Addendum No. 001

**Subject: Cooling Plant Replacement
SDP Contracts No. B-080C, B-081C and B-082 of 2017/18**

**Location: Thomas A. Edison High School
151 W Luzerne Street
Philadelphia, Pennsylvania 19140**

This Addendum, dated August 9, 2018, shall modify and become part of the Contract Documents for the work of this project. Any items not mentioned herein, or affected by, shall be performed strictly in accordance with the original documents.

E.02

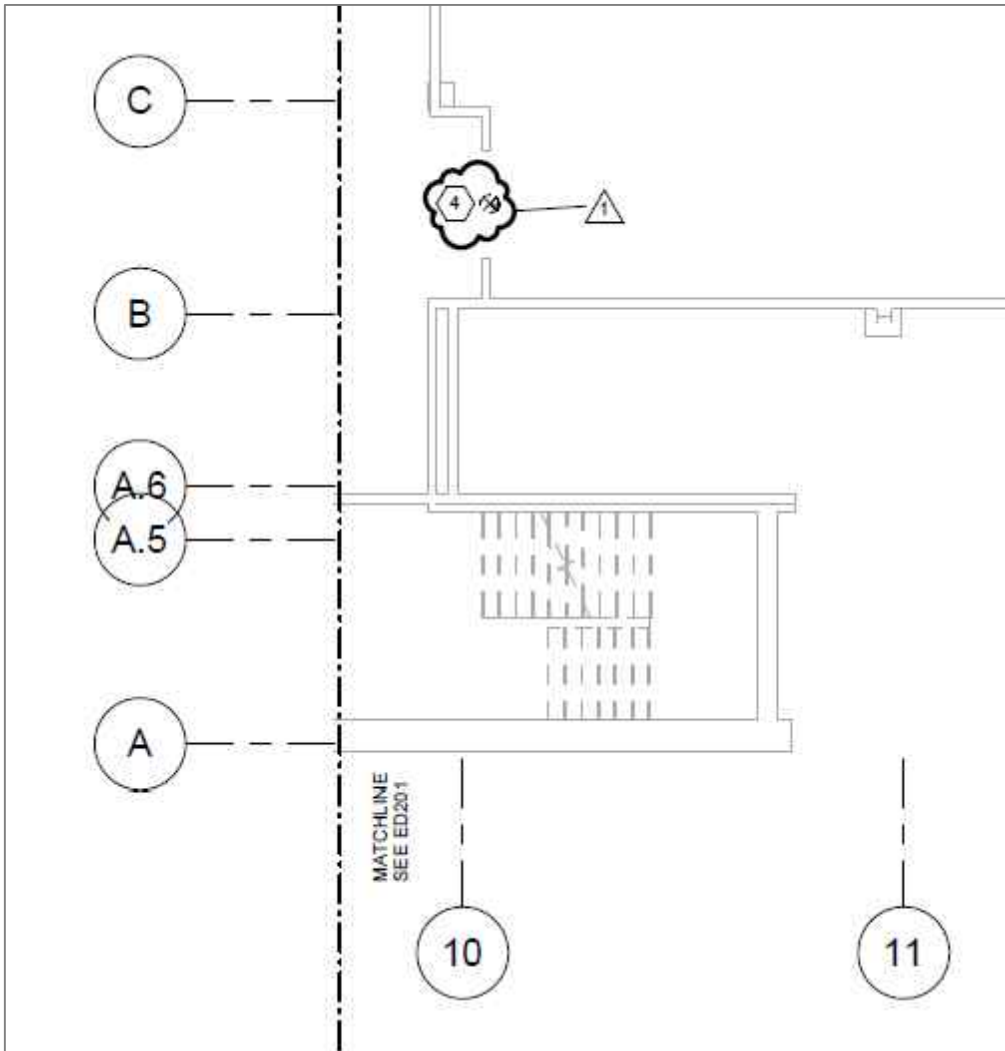
- **Added** existing exit sign at the end of corridor added to drawing, Refer to addendum Sketch E.02
- **Added** Keynote #4 addressing work on existing exit sign, Refer to addendum Sketch E.02

E.03
DRAWING NO.

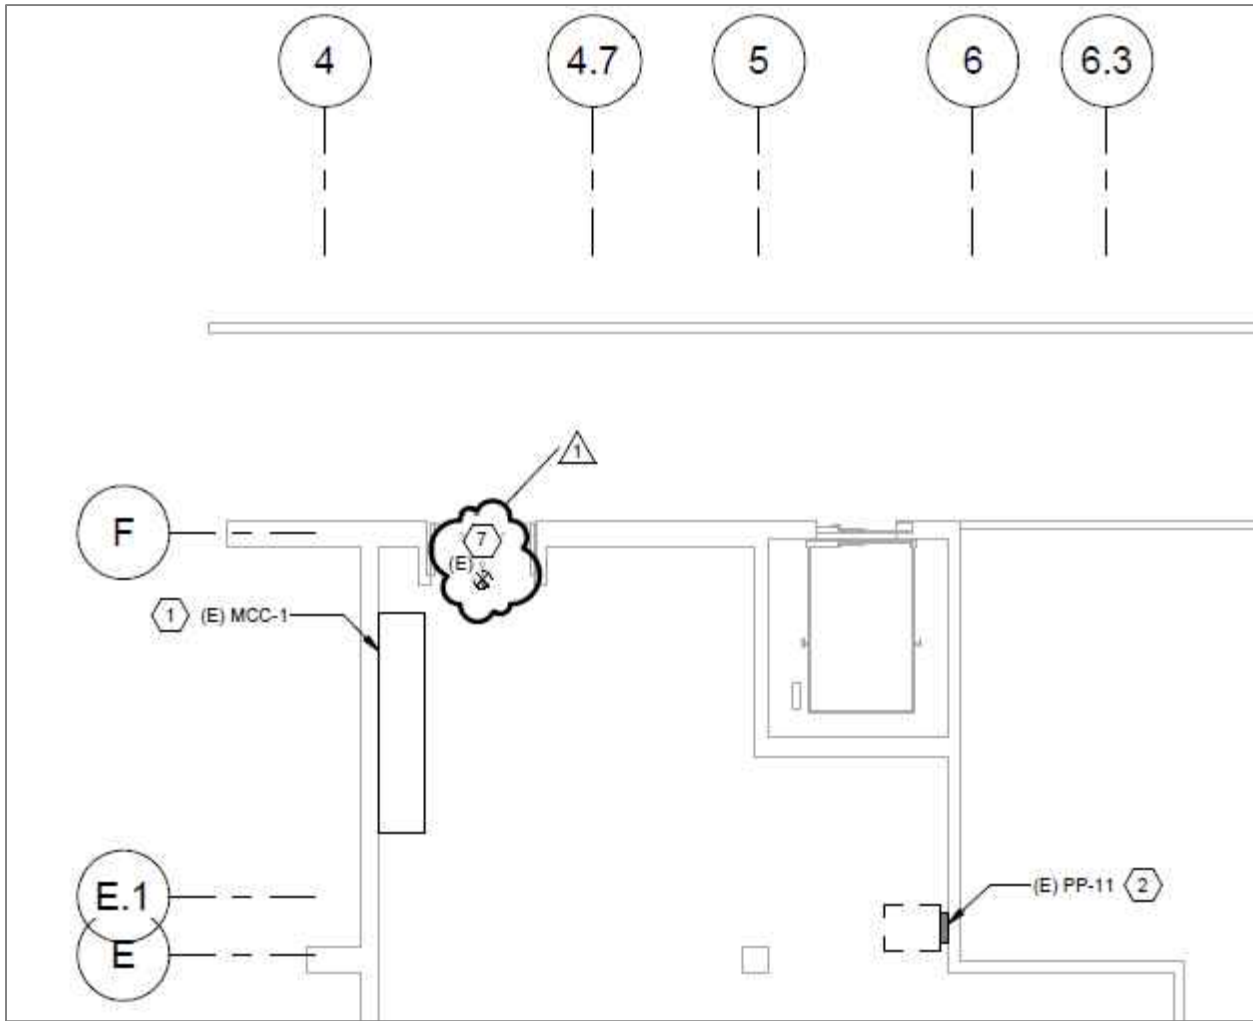
- **Added** existing exit sign at the end of the mechanical room to drawing. Refer to addendum Sketch E.03
- **Added** Keynote #7 addressing work on existing exit sign, Refer to addendum Sketch E.03

E.04

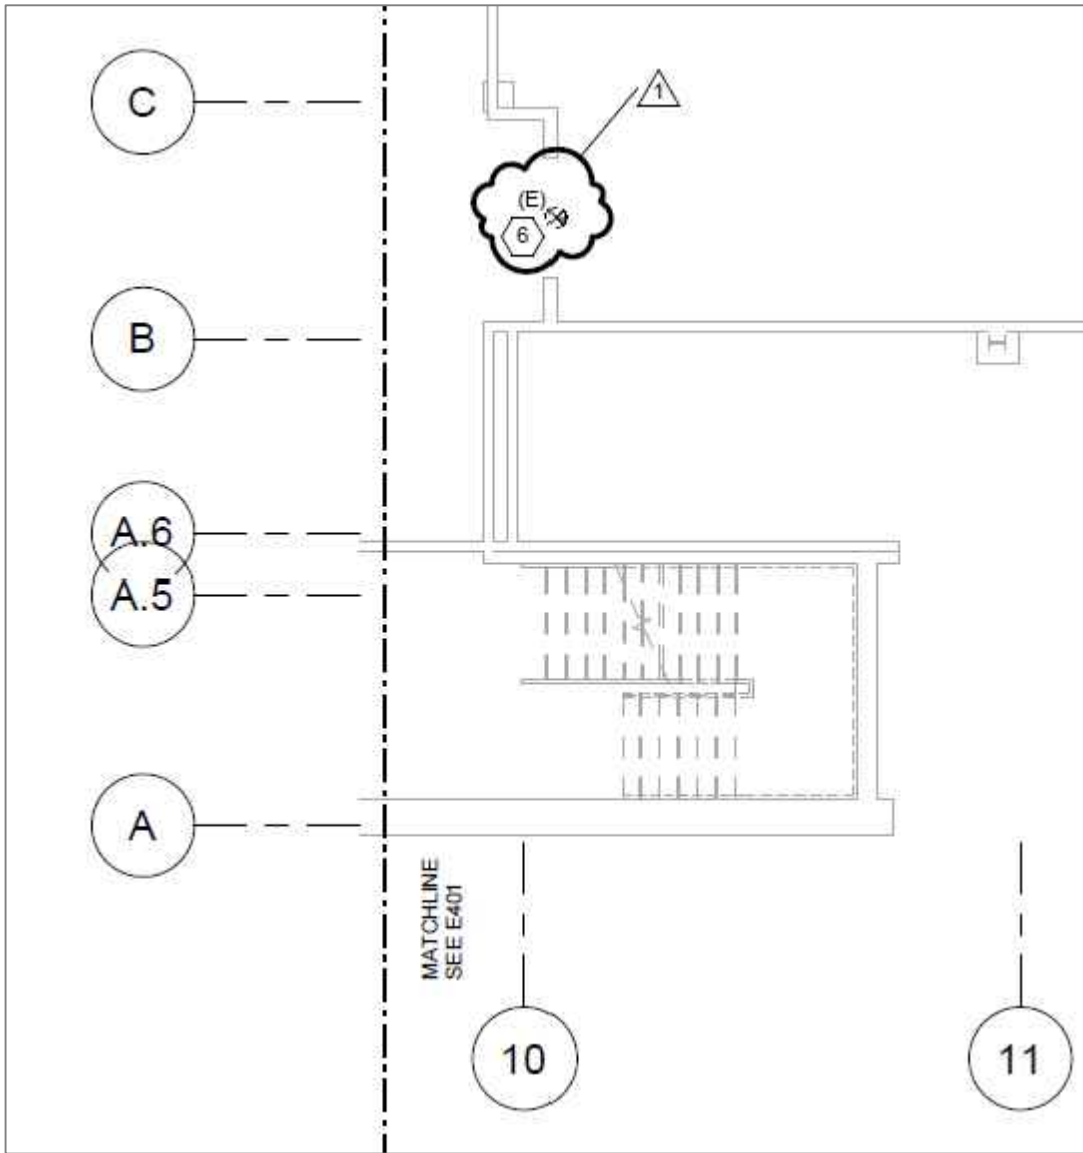
- **Added** Existing exit sign at the end of corridor to drawing, Refer to addendum Sketch E.04
- **Added** Keynote #6 addressing work on existing exit sign added, Refer to addendum Sketch E.04

E.05
DRAWING NO.

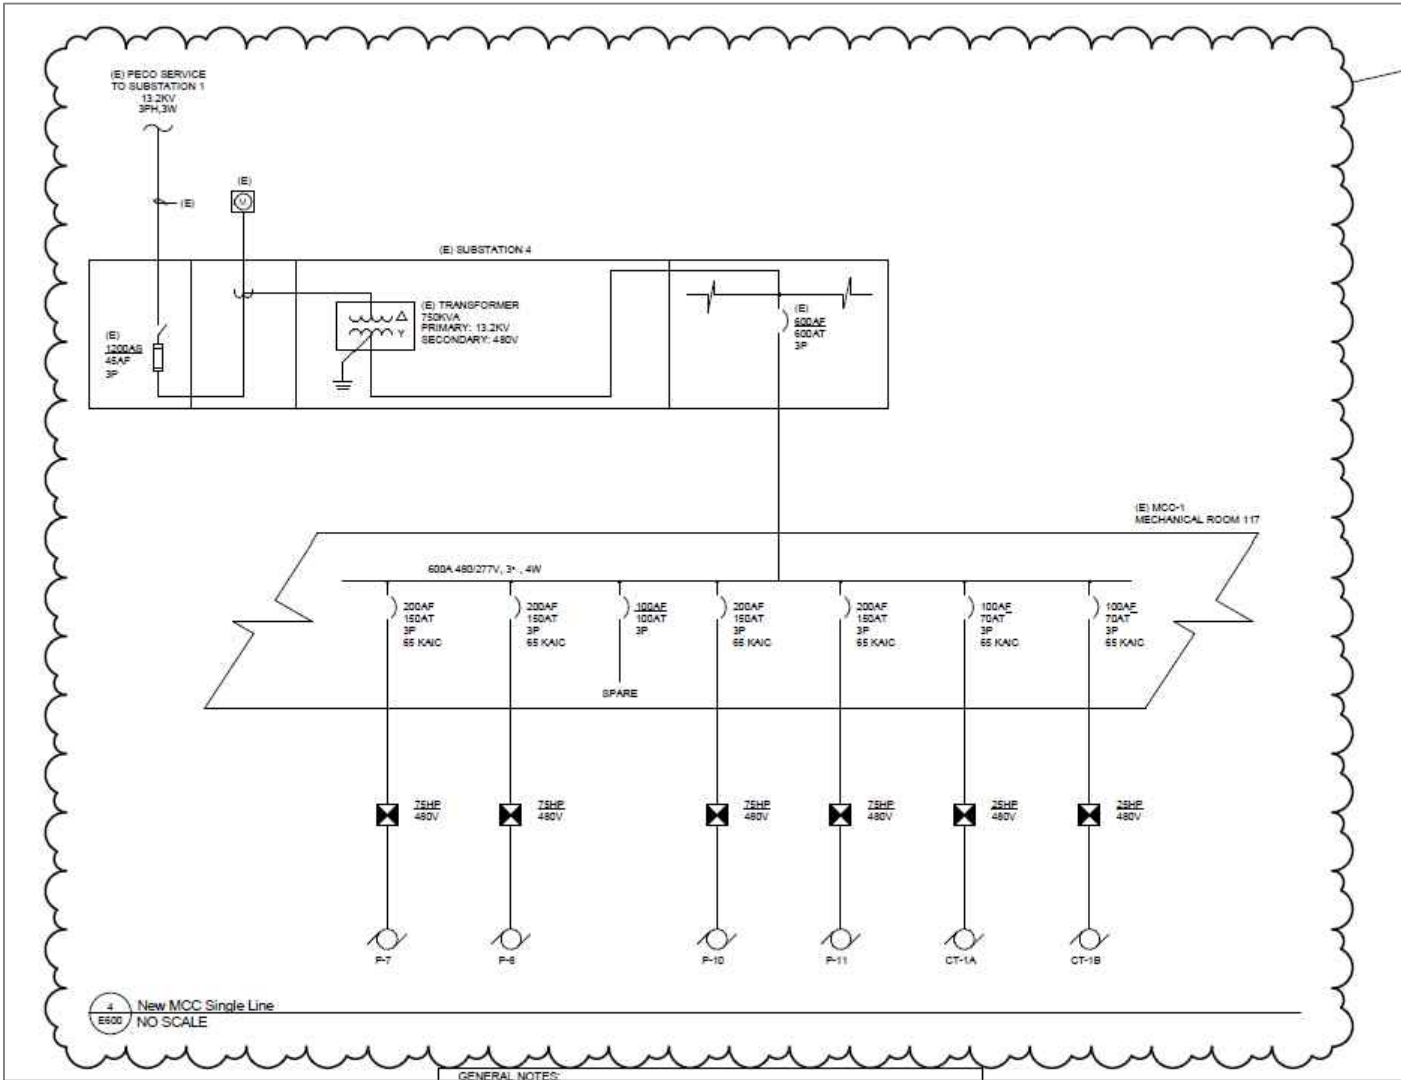
- **Changed** Detail #4 New MCC Single Line: Circuit breaker fuse sizes and trip sizes changed for pumps P-7, P-8, P-10, P-11, Refer to addendum Sketch E.05
- **Changed** Detail #4 New MCC Single Line: Circuit breaker trip sizes changed for cooling towers CT-1A, CT-1B, Refer to addendum Sketch E.05
